Thursday, August 25, 2022
10:00 am.

SUBDIVISION AUTHORITY MINUTES MEETING NO. 34

Subdivision Authority

TENTATIVE PLAN

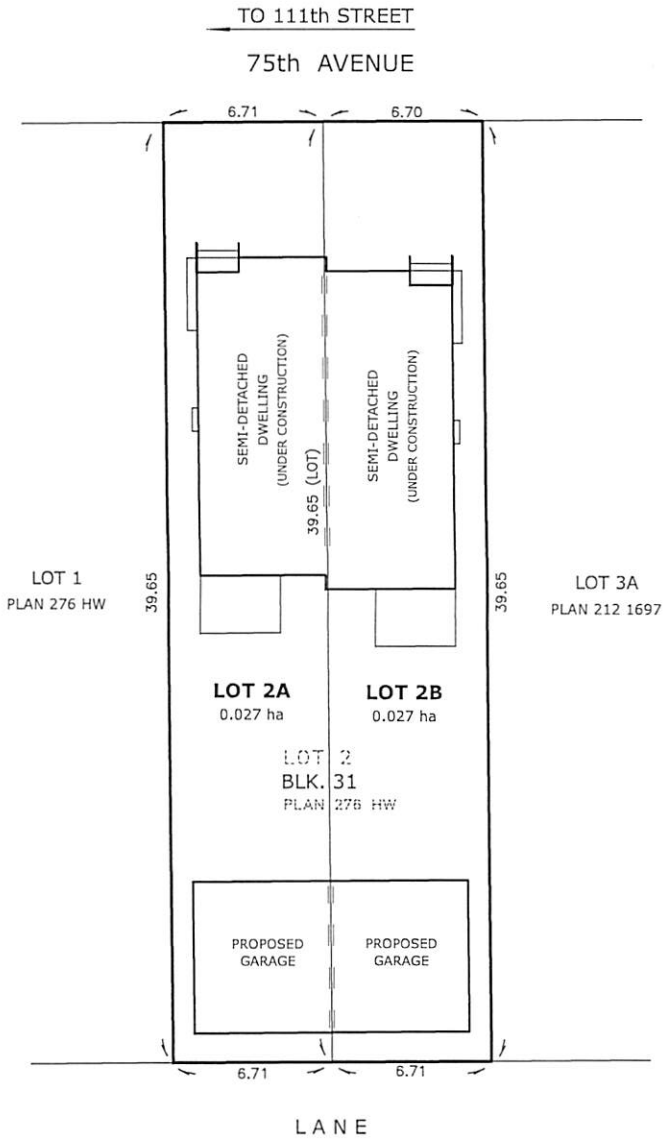
1. that the owner make satisfactory arrangements with EPCOR Water Services Inc. and EPCOR Drainage Services for the provision of separate services (water and sewer) to the proposed eastern lot; and
2. that the owner pay all outstanding property taxes prior to the endorsement of the plan of survey.

- There are existing boulevard trees adjacent to the site on 75 Avenue NW that must be protected during construction. For information about tree protection please refer to the City of Edmonton's website (search "Trees and Construction").
- Any and all costs associated with tree work requests (removal, pruning or other) and/or remediation from damages are borne on to the proponent as per the Corporate Tree Management Policy (C456C). All work is to be carried out by Urban Forestry who can be contacted at citytrees@edmonton.ca. Removal of City of Edmonton trees must follow the Live Tree Removal Guidelines which include community notice and value compensation.

- The existing services (water and sanitary) enter the proposed subdivision approximately 4.92 m east of the west property line of Lot 2 off 75 Avenue. As per the EPCOR Drainage Services Bylaw and the EPCOR Water Services and Wastewater Treatment Bylaw, these services cannot cross the proposed property line.

- If power service crosses the proposed property line the owner may be required to provide a blanket easement in favour of EPCOR Distribution & Transmission Inc. If required, said easement shall be registered prior to or concurrent with the final plan of survey (contact EPCOR Land Administration Group at 780-412-3252).

TENTATIVE PLAN

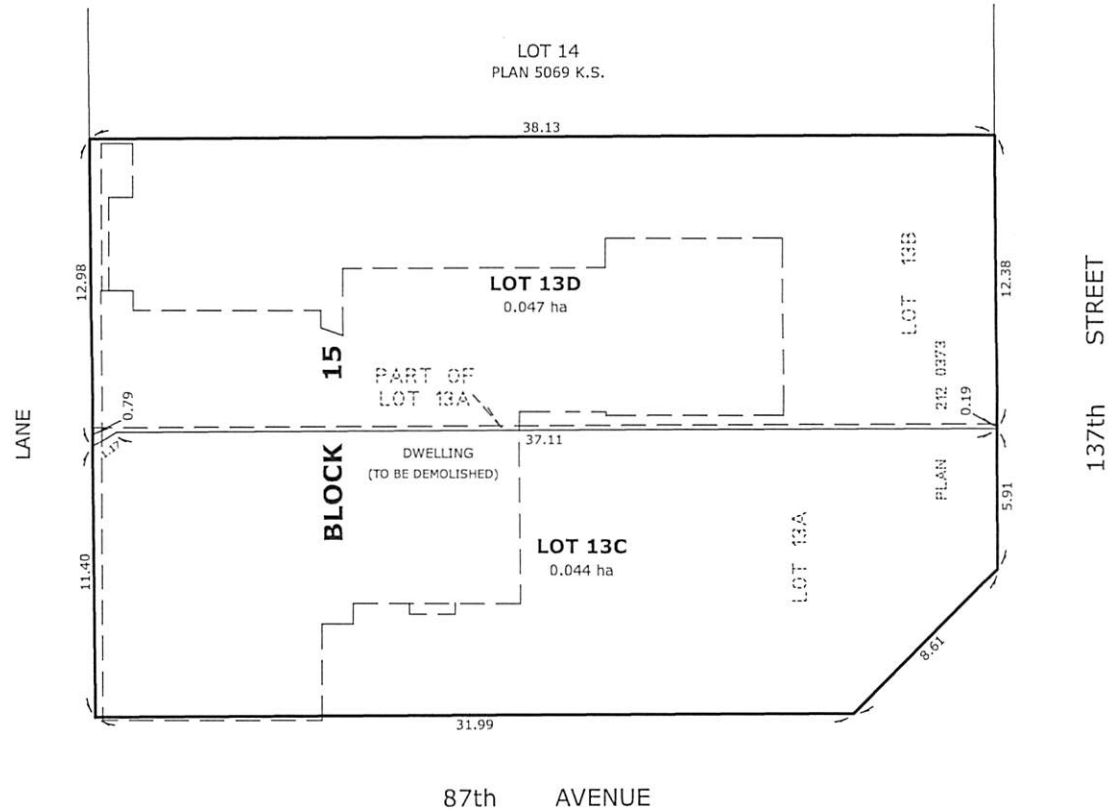
1. that the owner apply for a permit to demolish the existing dwelling prior to endorsement of the final plan. Demolition permits can be obtained from Development Services. Apply online at www.edmonton.ca/permits;
2. that the final plan of survey shall conform to the attached revised tentative plan; and
3. that the owner pay all outstanding property taxes prior to the endorsement of the plan of survey.

- There are existing boulevard trees adjacent to the site on 137 Street and 87 Avenue NW that must be protected during construction. For information about tree protection please refer to the City of Edmonton's website (search "Trees and Construction").

- Access for future development must be to the adjacent alley in conformance with Mature Neighbourhood Overlay Section 814.3(17) of the Zoning Bylaw #12800.

- There are existing accesses /driveways to 87 Avenue and 137 Street. Upon redevelopment of proposed Lot 13C or 13D, the existing residential accesses must be removed, as shown on the Enclosure. The owner/applicant will be required to obtain a Permit to remove the access, available from Development & Zoning Services, 2nd Floor, 10111 – 104 Avenue. Apply online at www.edmonton.ca/permits.

- The existing services (water and sanitary) enter the proposed subdivision approximately 11.9 m north of the south property line of Lot 13 off of the lane. The existing storm service enters the proposed subdivision approximately 11.9m south of the north property line of Lot 13 off 137 Street. As per the EPCOR Drainage Services Bylaw and the EPCOR Water Services and Wastewater Treatment Bylaw, these services cannot cross the proposed property line.

TENTATIVE PLAN SHOWING PROPOSED SUBDIVISION

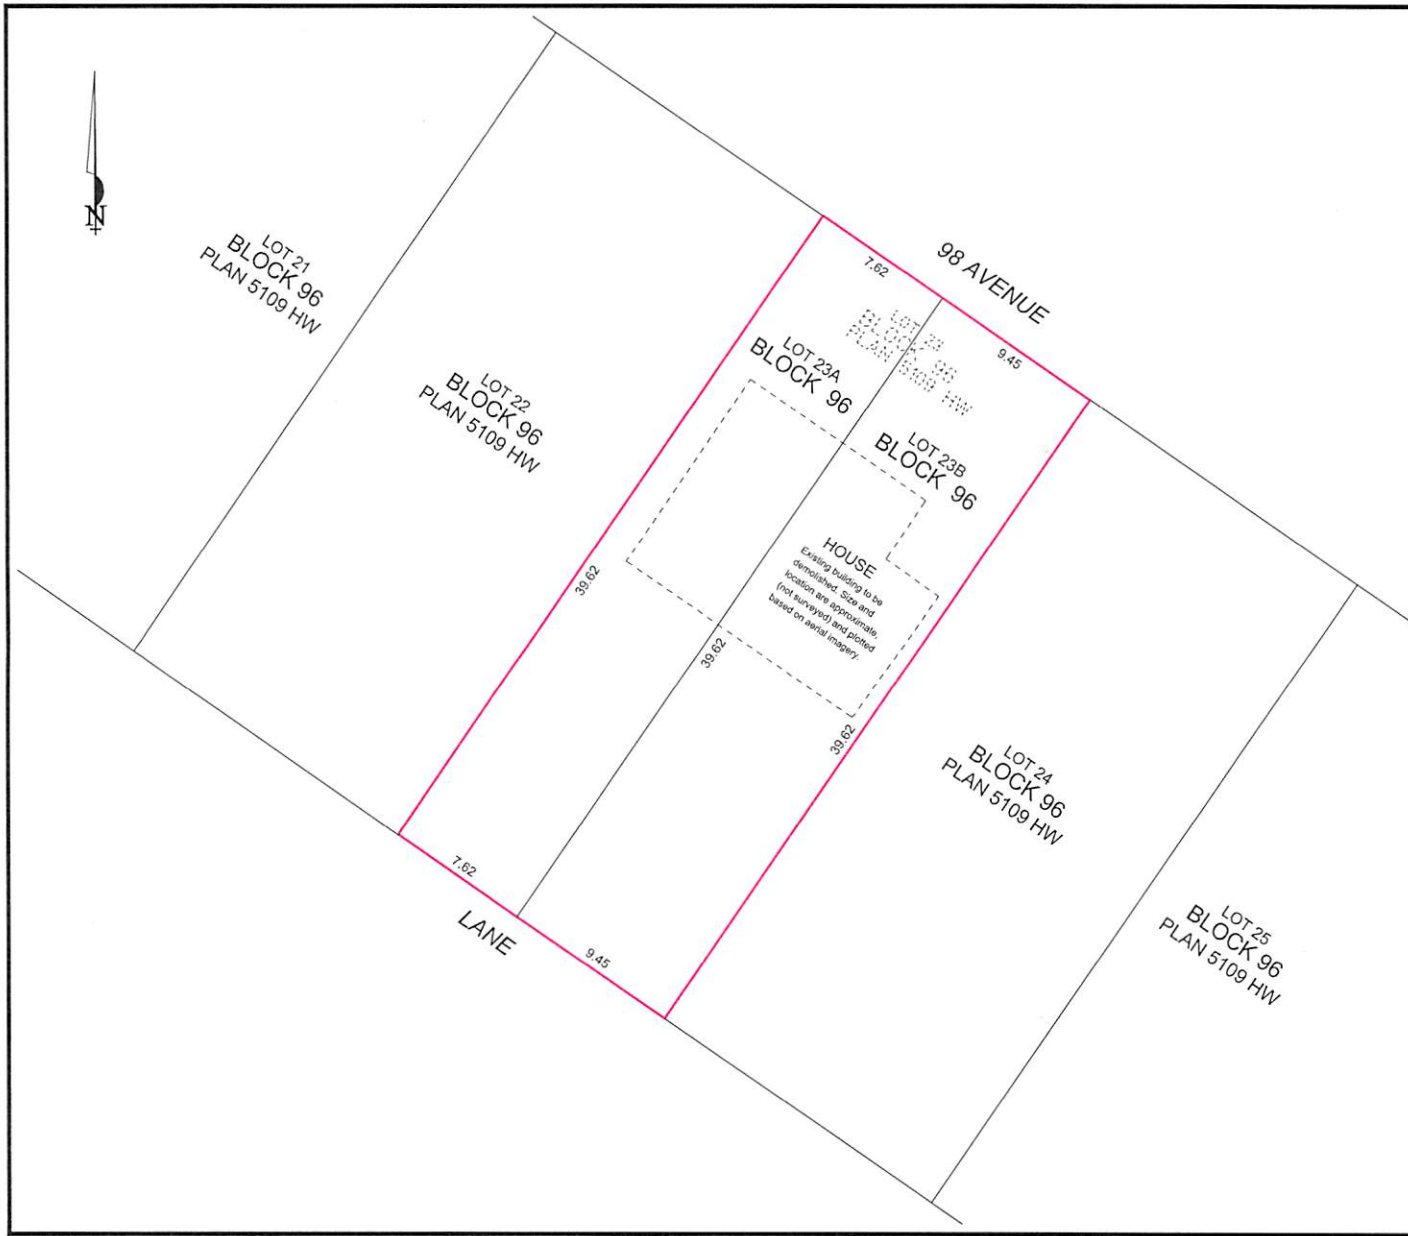
1. that the owner apply for a permit to demolish the existing dwelling and garage prior to endorsement of the final plan. Demolition permits can be obtained from Development Services. Apply online at www.edmonton.ca/permits; and
2. that the owner pay all outstanding property taxes prior to the endorsement of the plan of survey.

- There are existing boulevard trees adjacent to the site on 98 Avenue NW that must be protected during construction. For information about tree protection please refer to the City of Edmonton's website (search "Trees and Construction").

- Access for future development must be to the adjacent alley in conformance with Mature Neighbourhood Overlay Section 814.3(17) of the Zoning Bylaw #12800.

- There is an existing access to 98 Avenue NW. Upon redevelopment of proposed Lot 23B, the existing residential access to 98 Avenue NW must be removed. The owner/applicant will be required to obtain a Permit to remove the access, available from Development Services. Apply online at www.edmonton.ca/permits.

- The existing services (water and sanitary) enter the proposed subdivision approximately 13.9 m west of the east property line of Lot 23 off of the lane. The existing storm service enters the proposed subdivision approximately 8.99 m east of the west property line of Lot 23 off of 98 Avenue. As per the EPCOR Drainage Services Bylaw and the EPCOR Water Services and Wastewater Treatment Bylaw, these services cannot cross the proposed property line.

- There is a deficiency in on-street hydrant spacing adjacent to the property. The applicant/owner is advised to review on-site fire protection requirements to ensure adequate coverage (contact EPCOR Water at 780-412-3955).

- There is an existing power pole that may interfere with access to the proposed Lot 23A. Subdivision Planning recommends that the applicant/owner contact EPCOR Distribution & Transmission to confirm whether this pole will inhibit alley access to the site, which may result in

a delay with the issuance of the Development Permit. Contact EPCOR Customer Engineering Services for more information (ces@epcor.com).

ALLENDALE
TENTATIVE PLAN SHOWING PROPOSED
SUBDIVISION

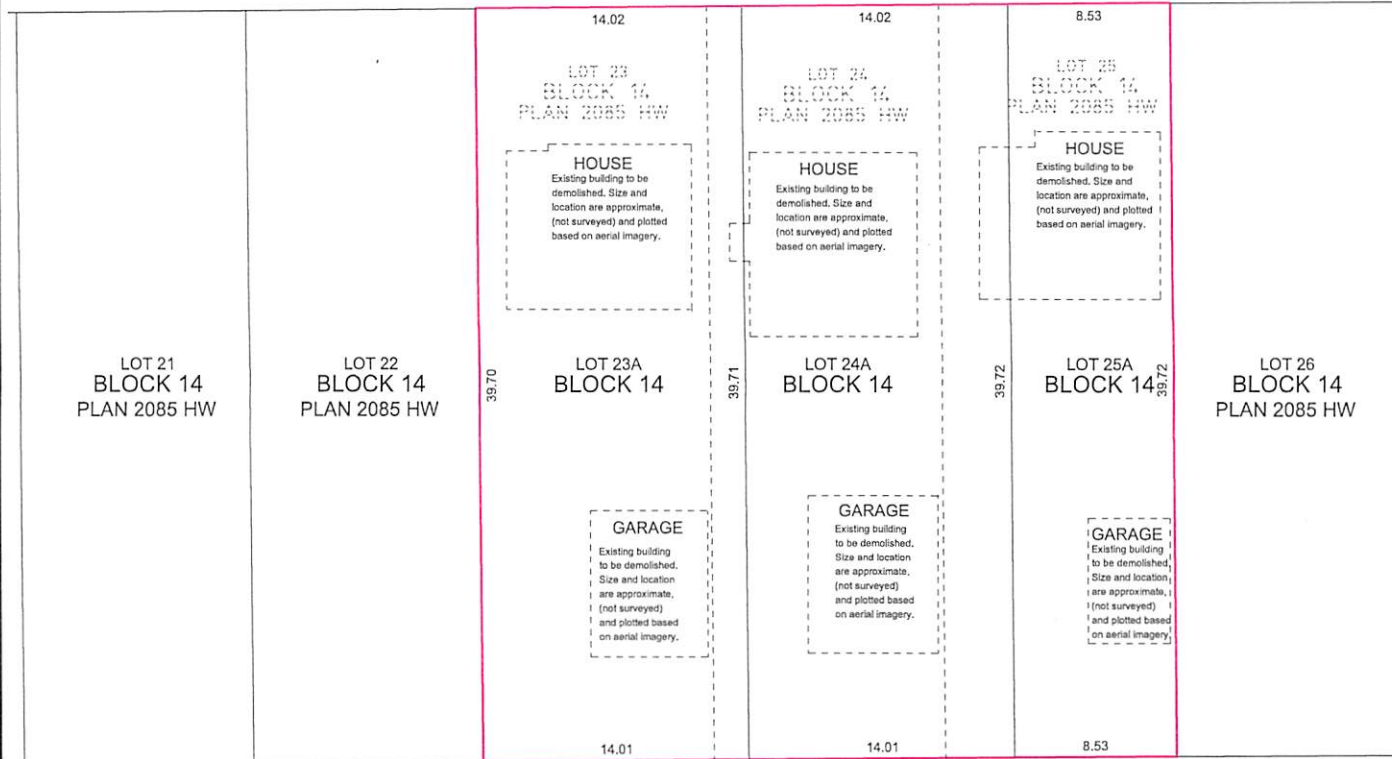
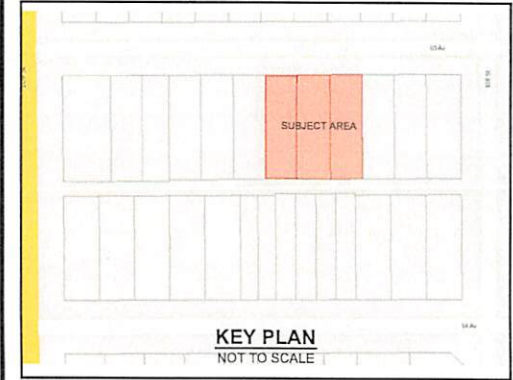
1. that the owner apply for a permit to demolish the existing dwellings and garages on Lots 24 and 25 prior to endorsement of the final plan. Demolition permits can be obtained from Development Services. Apply online at www.edmonton.ca/permits;
2. that the owner pay all outstanding property taxes prior to the endorsement of the plan of survey.

- There are existing boulevard trees adjacent to the site on 65 Avenue NW that must be protected during construction. For information about tree protection please refer to the City of Edmonton's website (search "Trees and Construction").

- Access for future development must be to the adjacent alley in conformance with Mature Neighbourhood Overlay Section 814.3(17) of the Zoning Bylaw #12800.

- The Allendale neighbourhood is on the Neighbourhood Alley Renewal Program. This specific site is scheduled for renewal sometime between 2023 to 2025. This renewal work includes addressing surface drainage issues in the alleys, providing a 4m width where possible, paving alley surfaces, and upgrading existing alley lighting to LED fixtures. Some alleys currently not identified for construction may be impacted as determined in the field at time of construction. Subdivision Planning recommends that the owner/applicant contact Program Manager Brenda Dola at 587-984-1608, or at brenda.dola@edmonton.ca. for information about project status, scope, timing or public engagement. To coordinate any work on road right-of-way, please email BuildingGreatNeighbourhoods@edmonton.ca.

- The existing services (water and sanitary) enter the proposed subdivision approximately 2.79 m east of the west property line of Lot 23 off 65 Avenue, 4.8 m east of the west property line of Lot 24 off 65 Avenue, and 2.81 m east of the west property line of Lot 25 off 65 Avenue. As per the EPCOR Drainage Services Bylaw and the EPCOR Water Services and Wastewater Treatment Bylaw, these services cannot cross the proposed property line.

- Multiple services are providing service to proposed Lot 24A. In accordance with City of Edmonton Design and Construction Standards Volume 4 (April 2021) Section 1.9.1.6.2, a Caveat of Restrictive Covenant for Check Valve Installation must be registered on title where more than one service is provided to a single lot. Check valves must be installed and maintained at the applicant's expense where looping of the water main back to the public system is planned or exists.

- Alternatively, the applicant may submit a request to abandon the service that will not be utilized for the proposed development to EPCOR Infill Water and Sewer Servicing.

- There is a deficiency in on-street hydrant spacing adjacent to the property. The applicant/owner is advised to review on-site fire protection requirements to ensure adequate coverage (contact EPCOR Water at 780-412-3955).

- After applying Edmonton Fire Rescue Services' (EFRS') Guideline for Accepting Spacing Deficiencies between Existing Hydrants for sites that require on-street fire flows 180L/s, it was determined that the existing hydrant spacing gap is acceptable. Therefore, upgrades to the existing municipal fire protection infrastructure is not required for this LDA (SUB) application.

- The results from the above-mentioned assessment applies to the current RF3 zoning. Future rezoning, subdivision and/or development permit applications will require a re-assessment by EPCOR Water Services Inc. (EWSI) and may trigger construction of upgrades to the existing municipal on-street fire protection infrastructure.

TENTATIVE PLAN OF SUBDIVISION
 LOT13 BLOCK 25 PLAN 4786HW

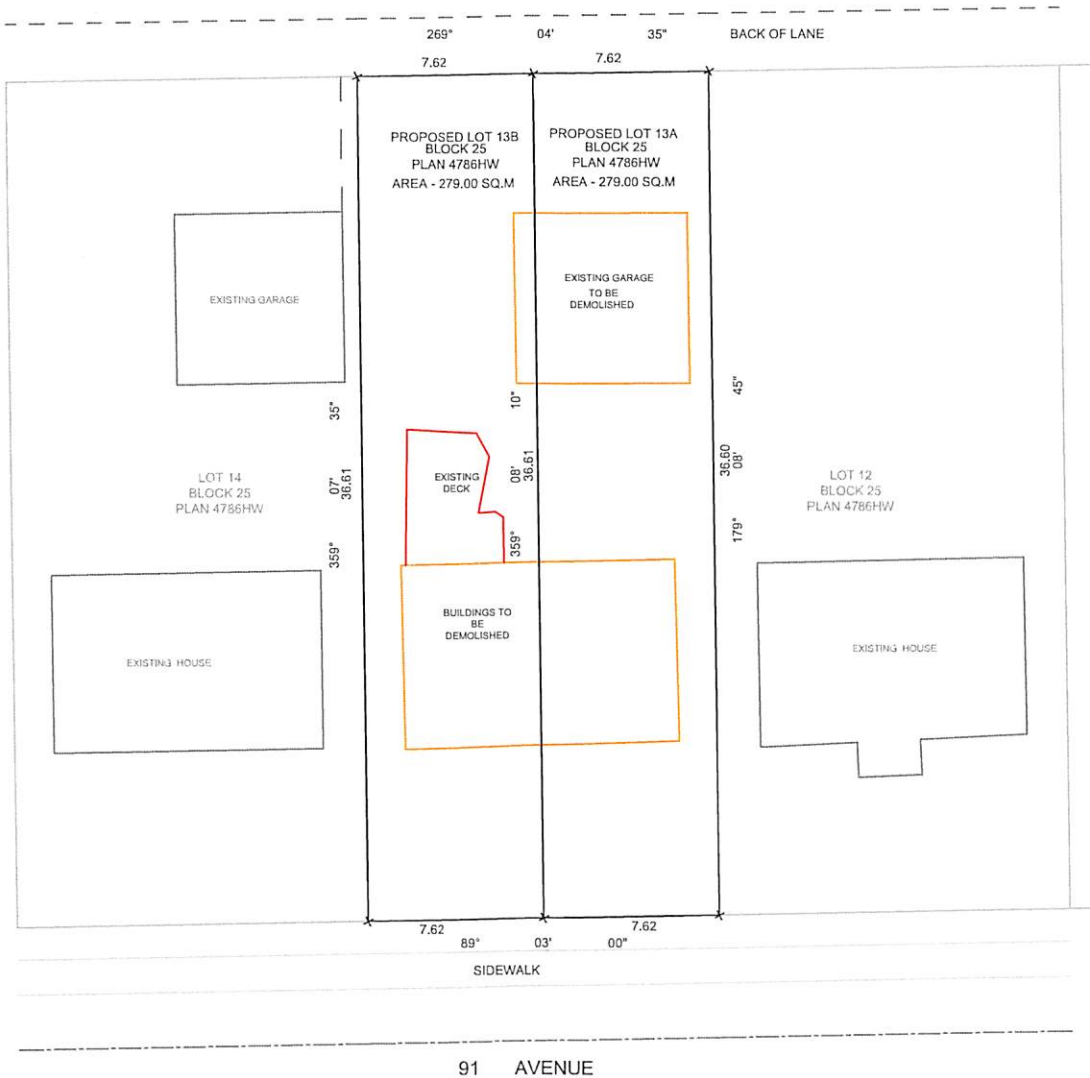
- There are existing boulevard trees adjacent to the site on 91 Avenue NW that must be protected during construction. For information about tree protection please refer to the City of Edmonton's website (search "Trees and Construction").
- Any and all costs associated with tree work requests (removal, pruning or other) and/or remediation from damages are borne on to the proponent as per the Corporate Tree Management Policy (C456C). All work is to be carried out by Urban Forestry who can be contacted at citytrees@edmonton.ca. Removal of City of Edmonton trees must follow the Live Tree Removal Guidelines which include community notice and value compensation.
- Access for future development must be to the adjacent alley in conformance with Mature Neighbourhood Overlay Section 814.3(17) of the Zoning Bylaw #12800.

- The existing services (water and sanitary) enter the proposed subdivision approximately 9.26 m east of the west property line of Lot 13 off of the lane. As per the EPCOR Drainage Services Bylaw and the EPCOR Water Services and Wastewater Treatment Bylaw, these services cannot cross the proposed property line.

- There is a water main located within a laneway adjacent to the north property line of Lot 13. Any party proposing construction involving ground disturbance to a depth exceeding 2.0 m is required to enter into a Facility Proximity Agreement with EPCOR Water, prior to performing the ground disturbance. Please contact waterlandadmin@epcor.com with your request or for more information.

- There is a deficiency in on-street hydrant spacing adjacent to the property. The applicant/owner is advised to review on-site fire protection requirements to ensure adequate coverage (contact EPCOR Water at 780-412-3955).

TENTATIVE PLAN SHOWING PROPOSED
SUBDIVISION

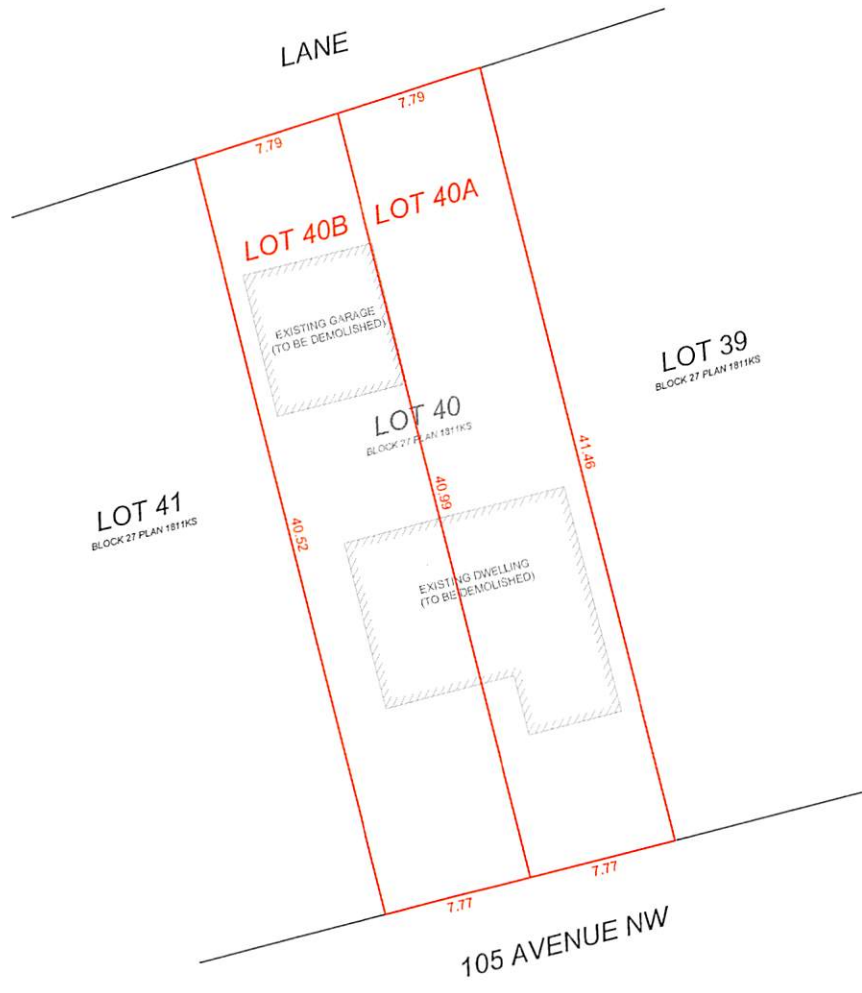
1. that the owner apply for a permit to demolish the existing dwelling and garage prior to endorsement of the final plan. Demolition permits can be obtained from Development Services. Apply online at www.edmonton.ca/permits; and
2. that the owner pay all outstanding property taxes prior to the endorsement of the plan of survey.

- Access for future development must be to the adjacent alley in conformance with Mature Neighbourhood Overlay Section 814.3(17) of the Zoning Bylaw #12800.

- The existing services (water and sanitary) enter the proposed subdivision approximately 9.87 m east of the west property line of Lot 40 off of the lane. The existing storm service enters the proposed subdivision approximately 2.87 m east of the west property line of Lot 40 off 105 Avenue. As per the EPCOR Drainage Services Bylaw and the EPCOR Water Services and Wastewater Treatment Bylaw, these services cannot cross the proposed property line.

- There is a water main located within a laneway adjacent to the north property line of Lot 40. Any party proposing construction involving ground disturbance to a depth exceeding 2.0 m is required to enter into a Facility Proximity Agreement with EPCOR Water, prior to performing the ground disturbance. Please contact waterlandadmin@epcor.com with your request or for more information.
